Product Change Notification: PC600013  
Bel Stewart Connector Customers and Sales Force,

11/15/11

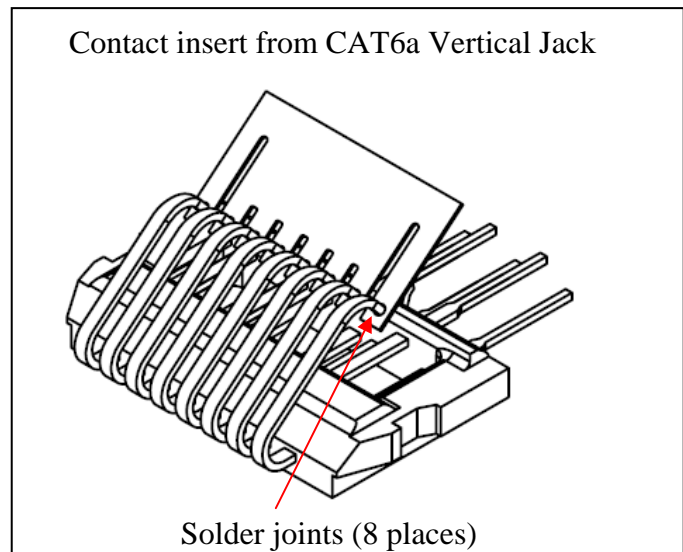
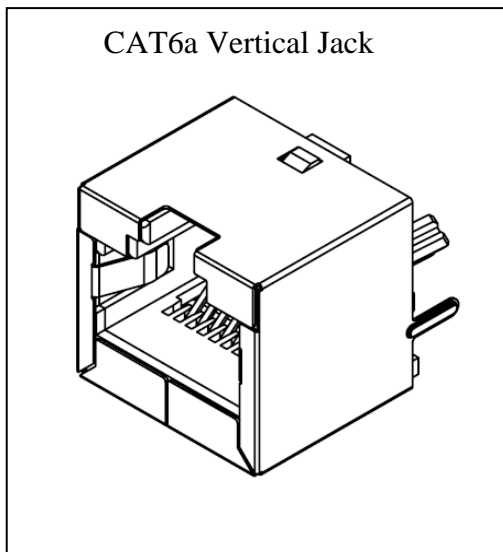
- 2) Process change from hand soldering to wave soldering of flexible PCB's to the contact array.
  - As shown in the illustration below there is a flexible PCB soldering to the contact array of the connector. Currently this soldering operation is a manual operation.
  - In the new process, this soldering will be done using a wave soldering operation.
  - There will be no visible changes to the product made using the wave soldering operation versus the hand soldering operation.
